HUANG FAMILY TRUST APARTMENTS 190 High St, Lower Hutt BC & TENDER 07 JUNE 2019

BUILDING CONSENT

GRANTED
16/08/2019

HUTT CITY COUNCIL

Proposed Plan

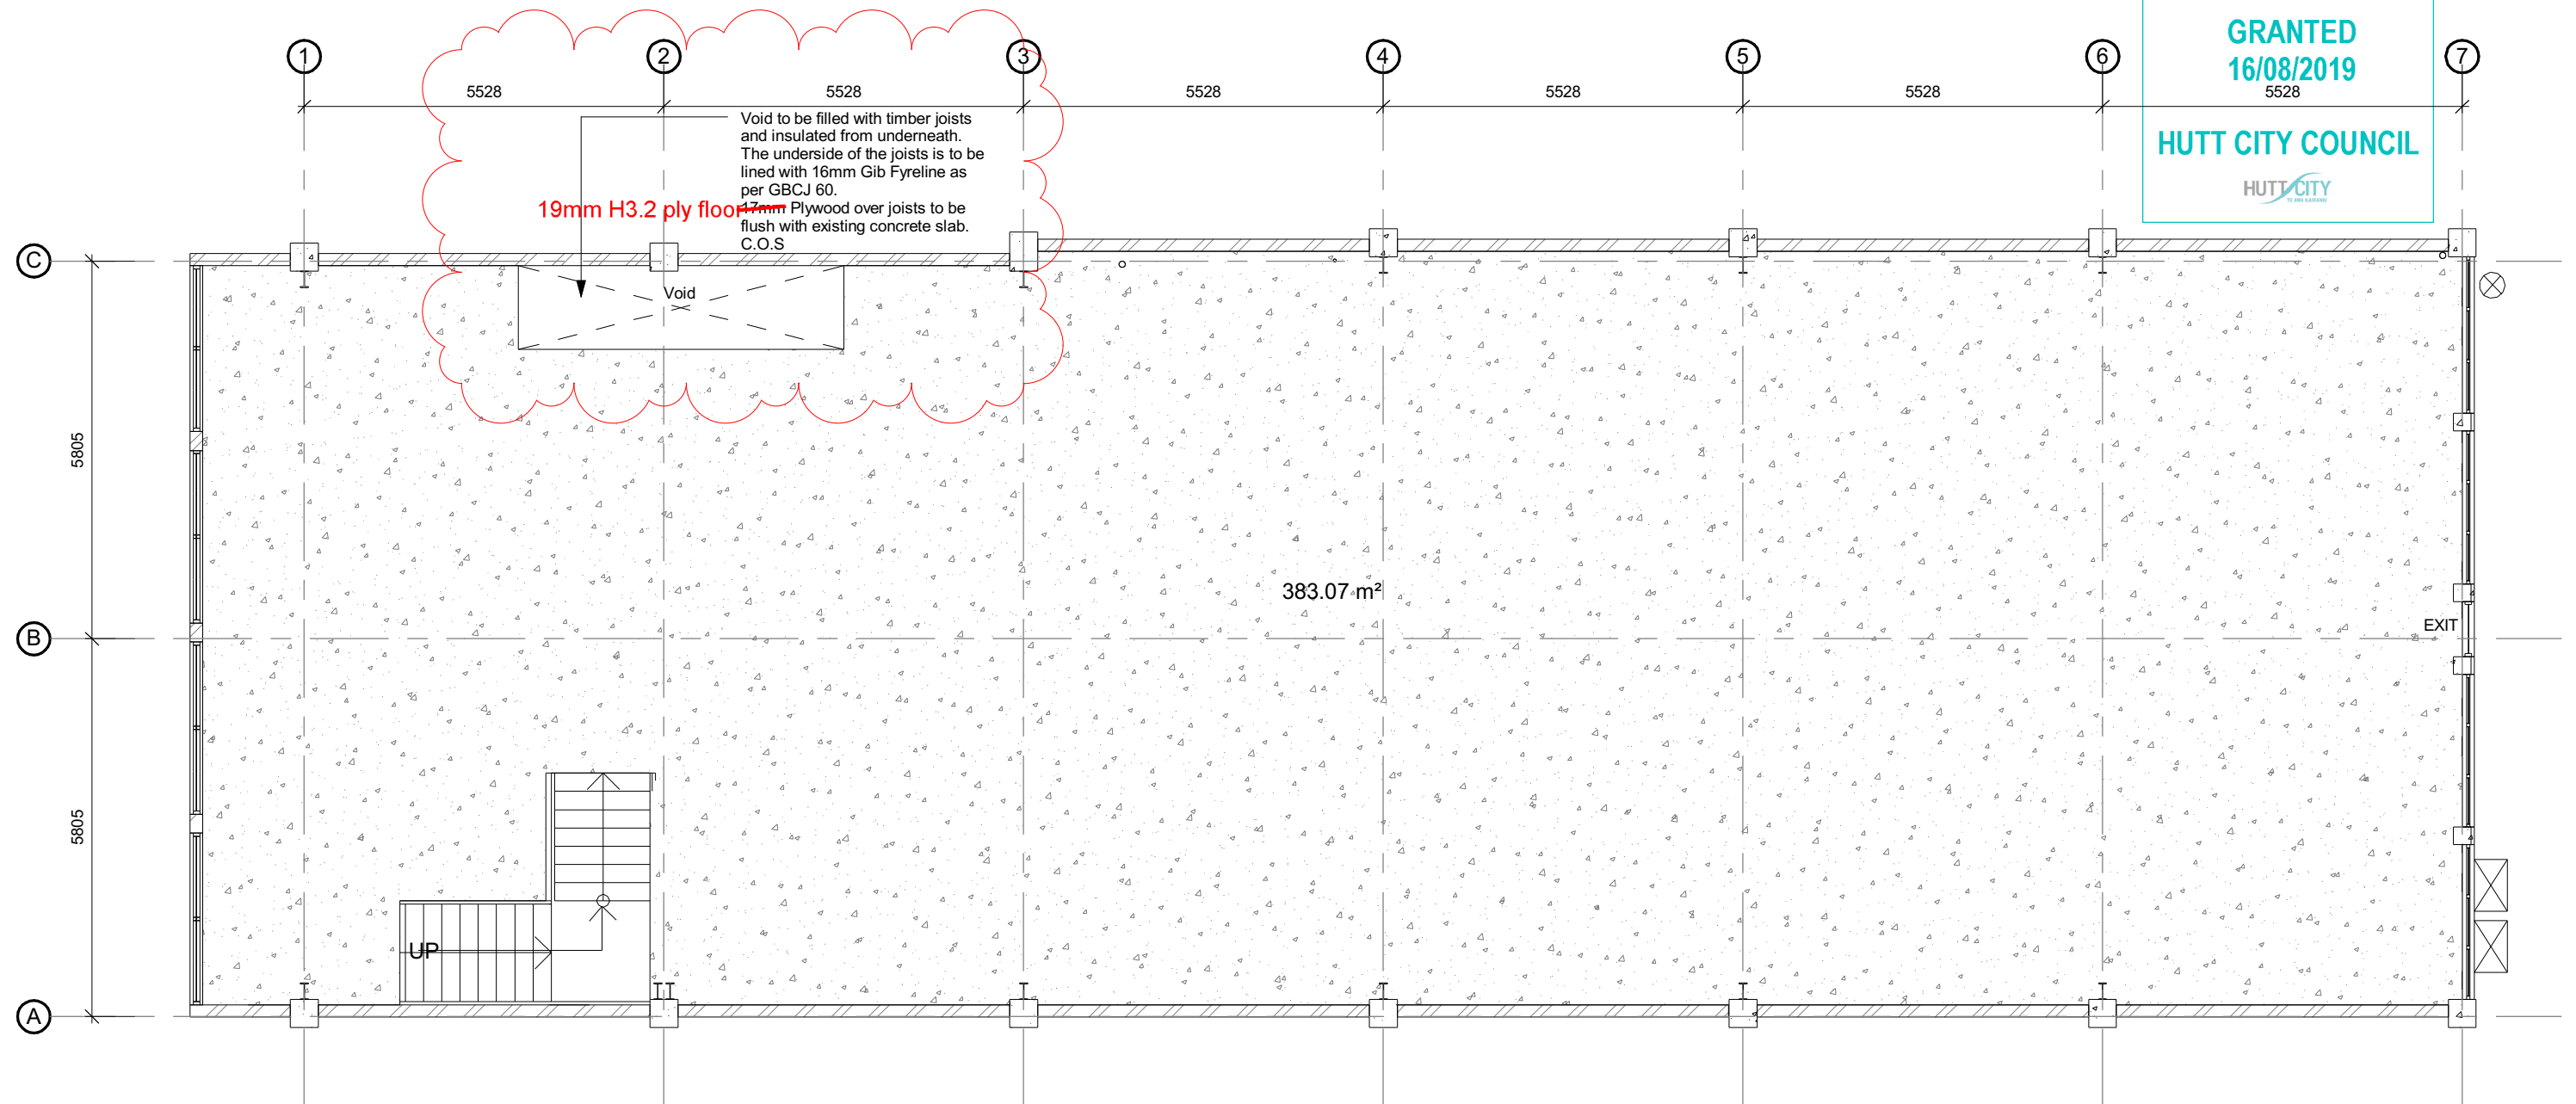
Entry to First floor apartments
to be controlled by contractor on
site to keep public out.

Note:
Hallway and stairwell lights
to be on a timer and sensor
system.

Door D0.01 leafs to be upgraded to have a clear opening of 760mm as per D1/AS1.

1 **First Floor Proposed Plumbing and Drainage Plan**
A252 SCALE @ A3 - 1 : 100

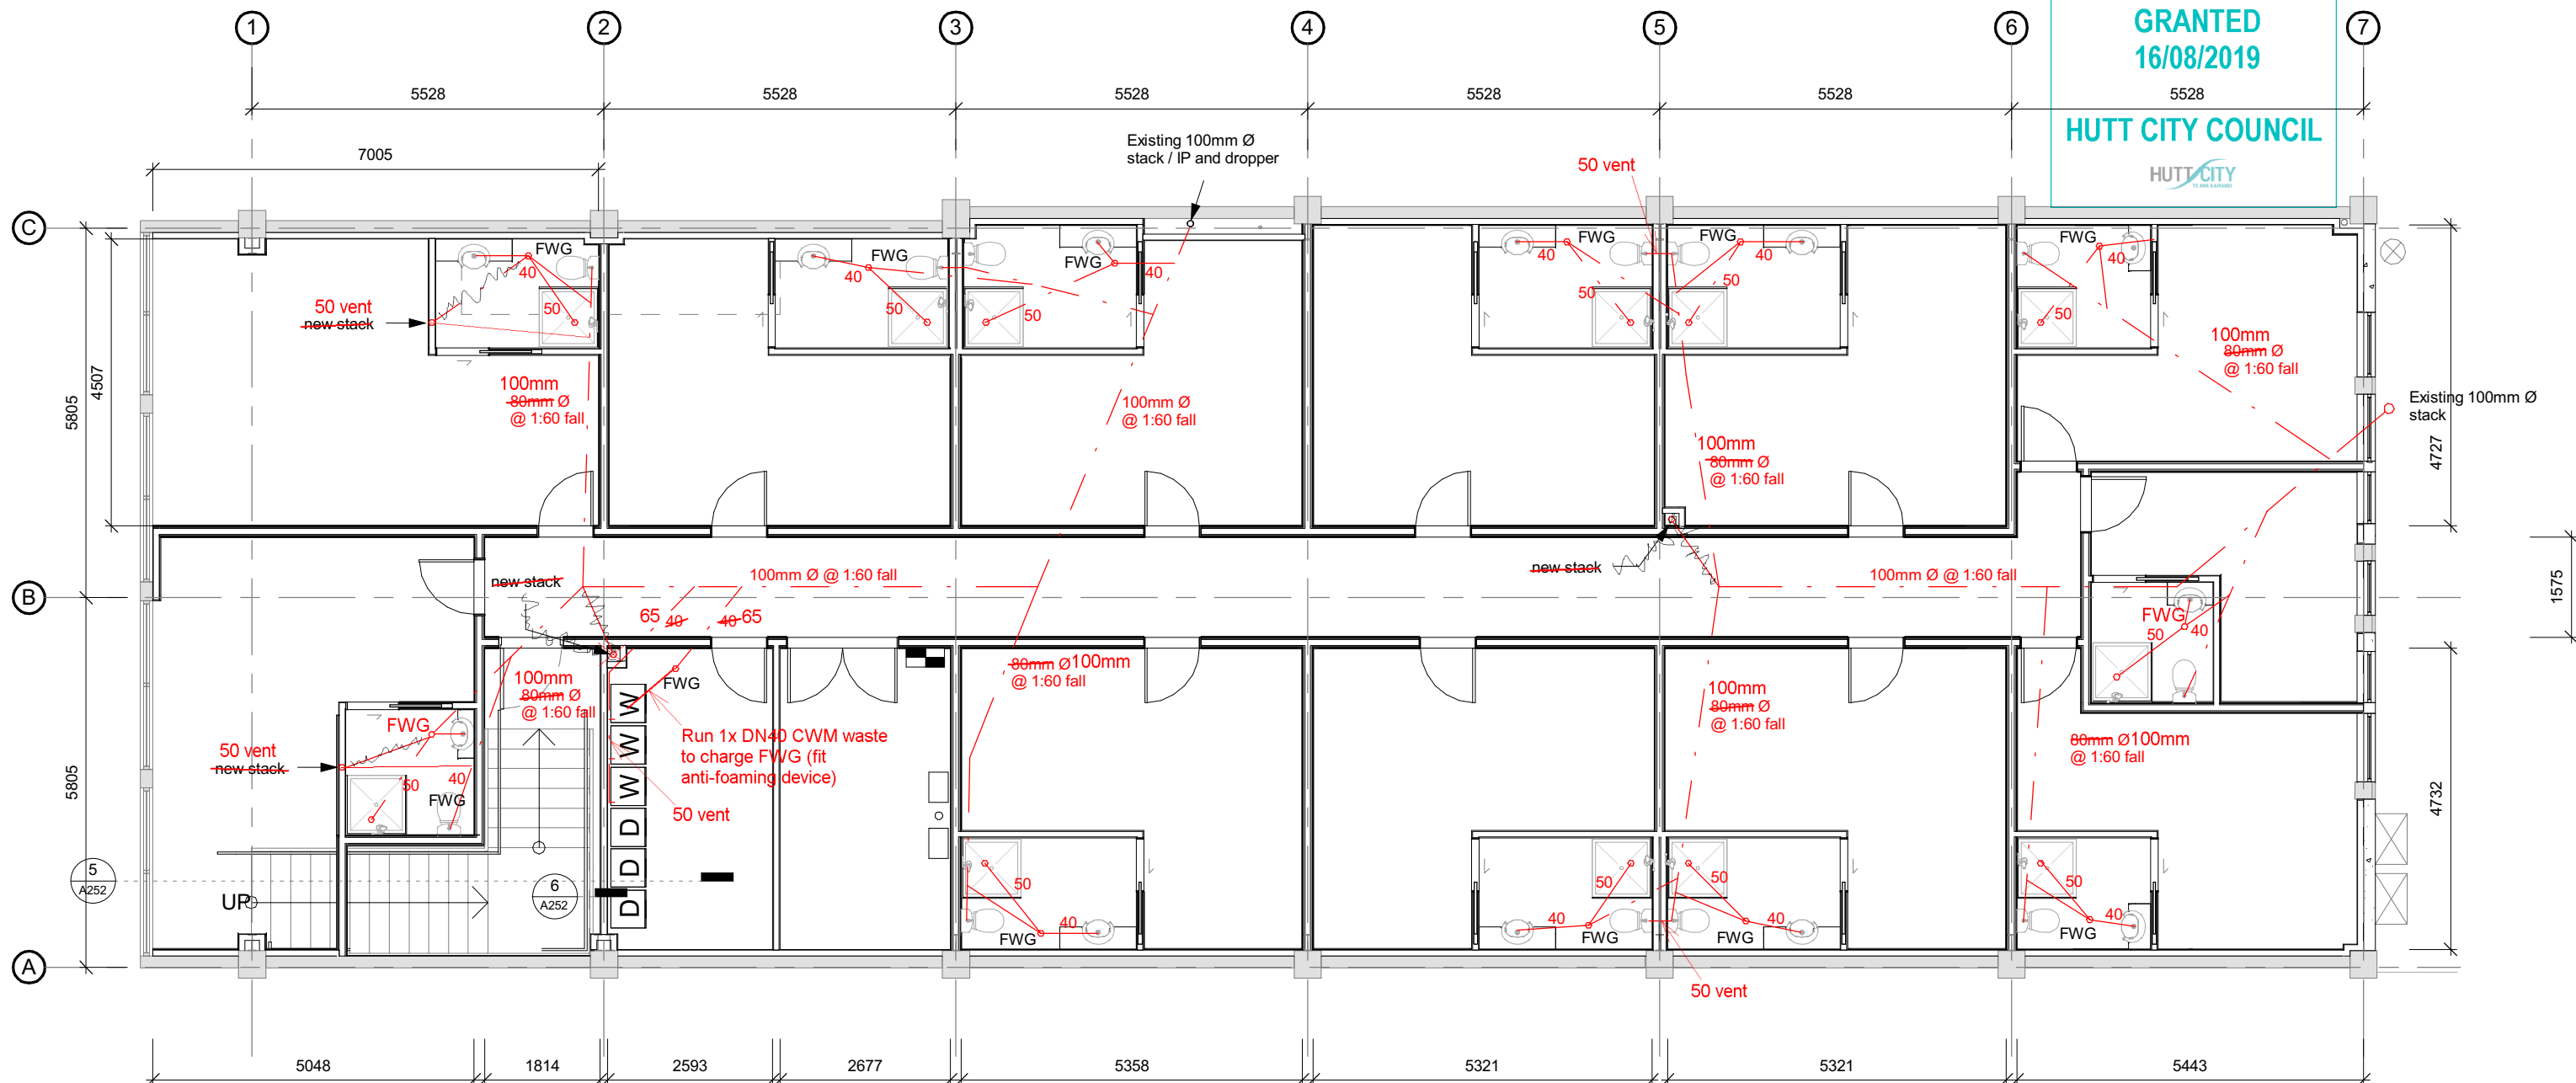
HCC note:

- All drainage work to AS/NZS3500.2 section-8 to Fully Vented Modified type stack system
- DN100 to primary lines and wc branches @ min 1:60
- DN65 to all FWG & Laundry branches @ min 1:40
- DN40 WHB & DN50 SHWR wastes to FWG's (max. 2.5m long)
- DN50 group vents within 1.5m of topmost fixture trap on the group branch
- Max 10x fixtures per vent group
- Max 6m long DN100 discharge branch to common vented branch
- Max 2.5m long DN65 discharge branch to common vented branch
- Min. 60-minutes rated fire collars & seals to all floor penetrations
